PLANNING COMMISSION
DATE: 6/30/14
AGENDA ITEM: 5A – BUSINESS ITEM
CASE # 2014-36

ITEM: Village Preserve South - Sketch Plan Review
SUBMITTED BY: Nick Johnson, City Planner
REVIEWED BY: Kyle Klatt, Community Development Director
Jack Griffin, City Engineer
Ann Pung-Terwedo, Washington County

SKETCH PLAN 06-16-14
VILLAGE PRESERVE SOUTH
(Parcel E, Holiday Parcel)
GWSA LAND DEVELOPMENT

TYPICAL SECTION

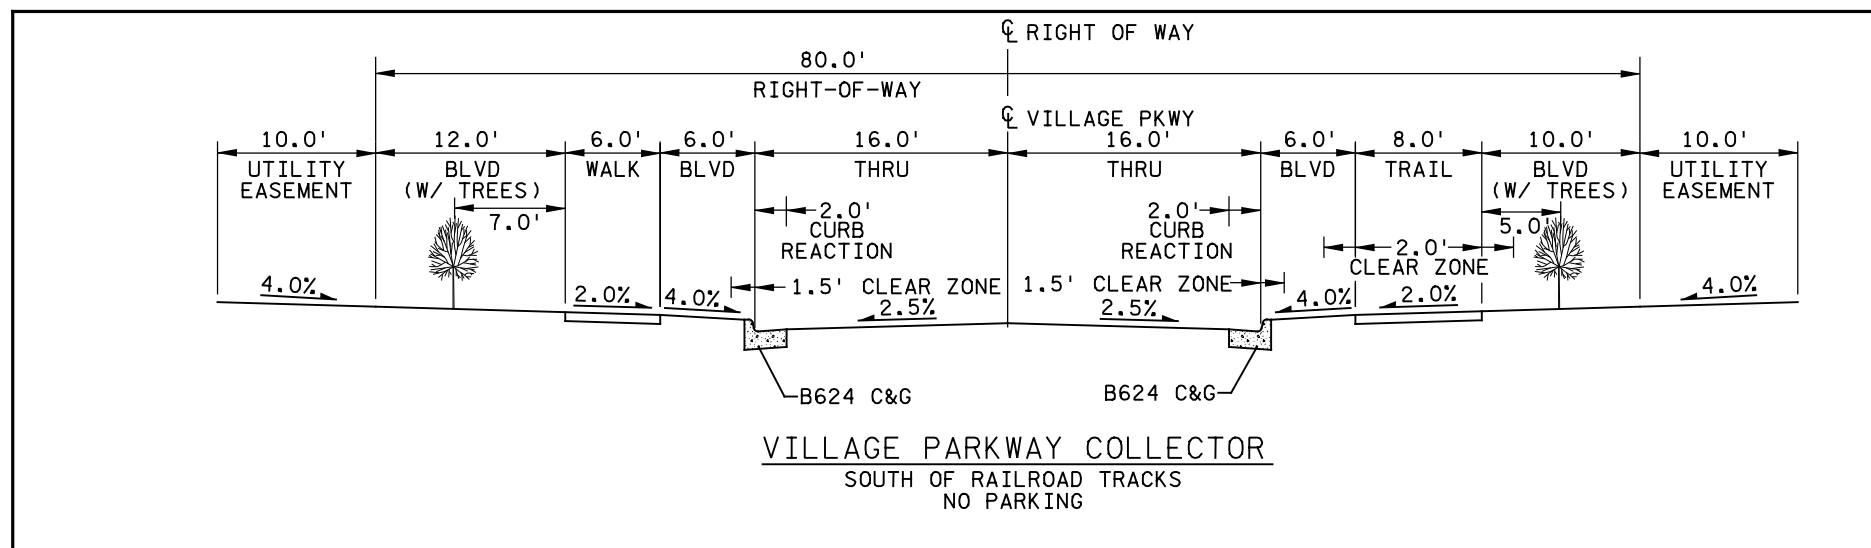
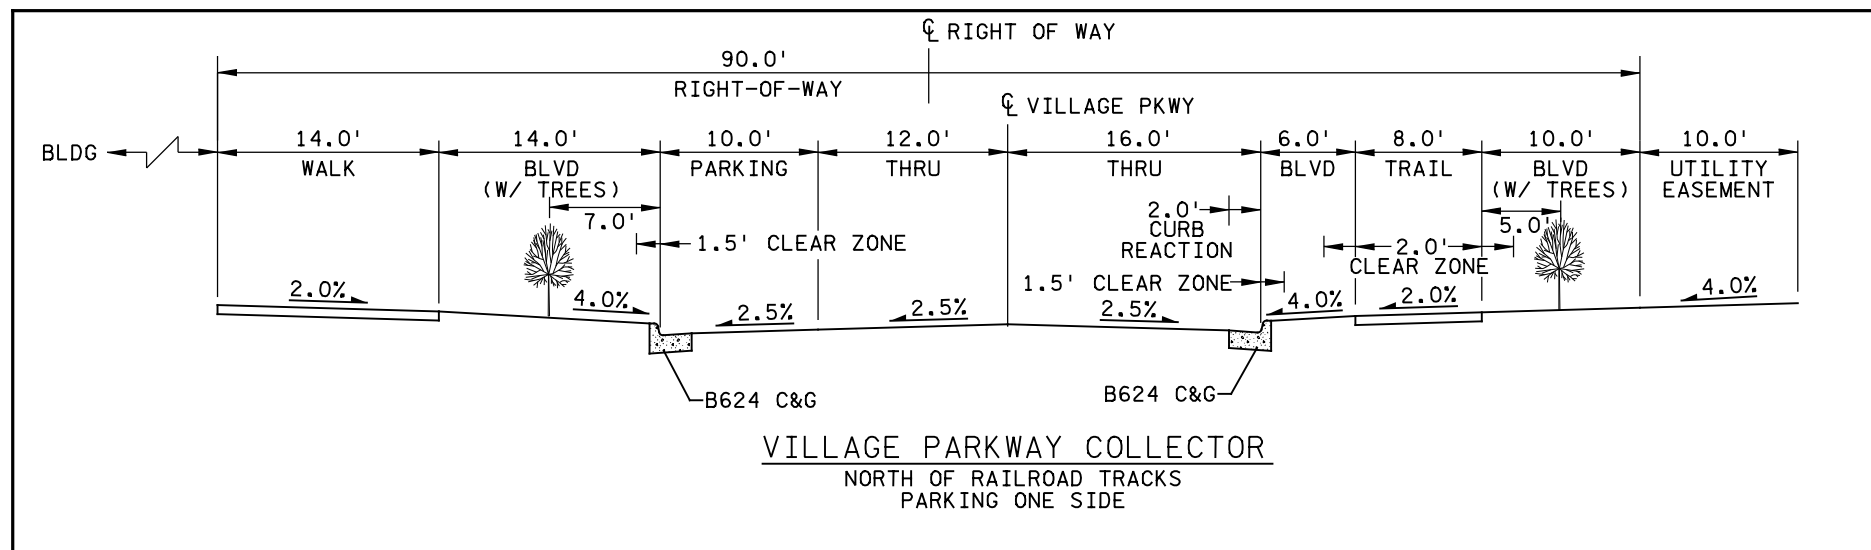
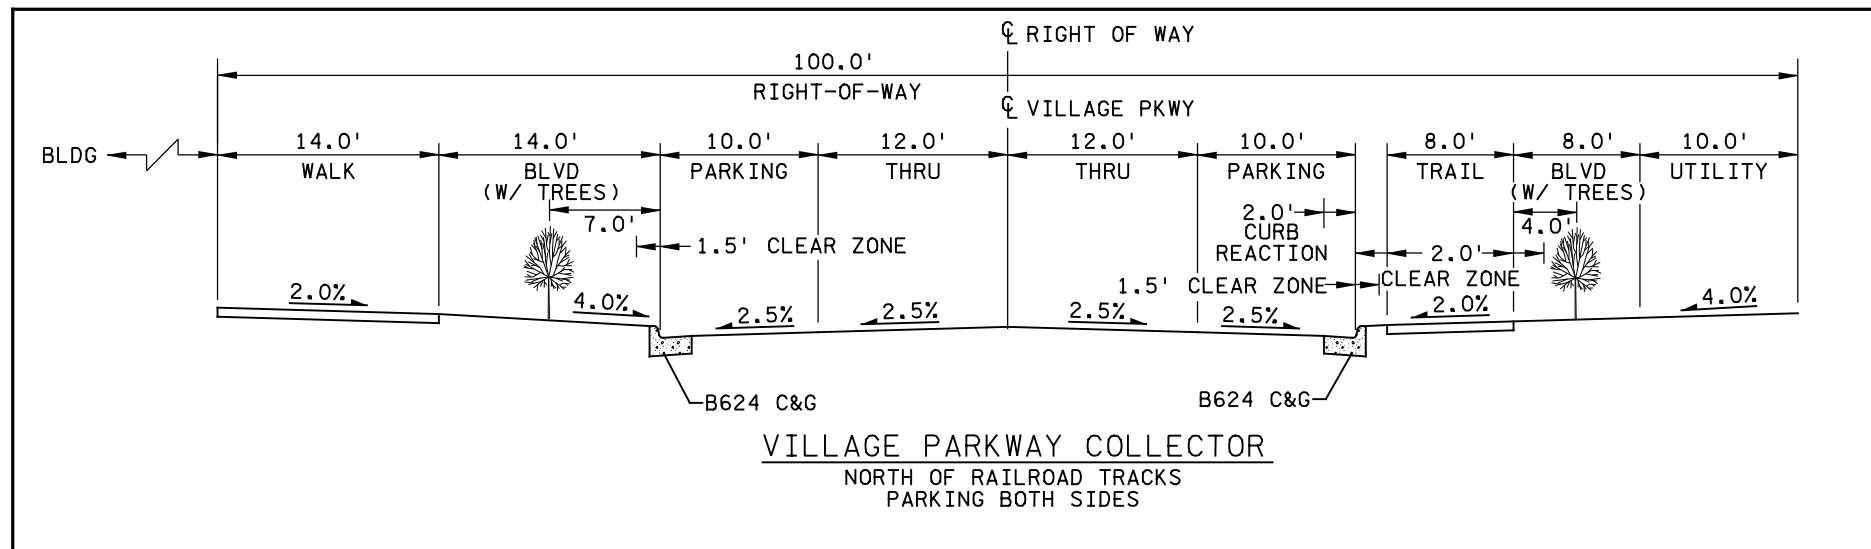
- **Streets.** The Sketch Plan includes residential streets with 60' rights-of-way and 28' streets, back of curb to back of curb. This design is consistent with the City standard for local residential streets, and would allow for parking on both sides of the street while maintaining safe traffic circulation and emergency vehicle access. It should be noted that no longer cul-de-sacs are being proposed as part of the subdivision. However, a small cul-de-sac with 4 larger residential lots is planned in the southern portion of the subdivision directly off the minor collector road. Given that Village Parkway is residential collector with low design speed (35mph), it is likely that the design will work. However, staff would like to study the design of the intersection at the cul-de-sac in greater detail. In terms of the design of the Village Parkway minor collector road, the proposed design shown in the Sketch Plan is consistent with the City's typical section (Attachment #5).
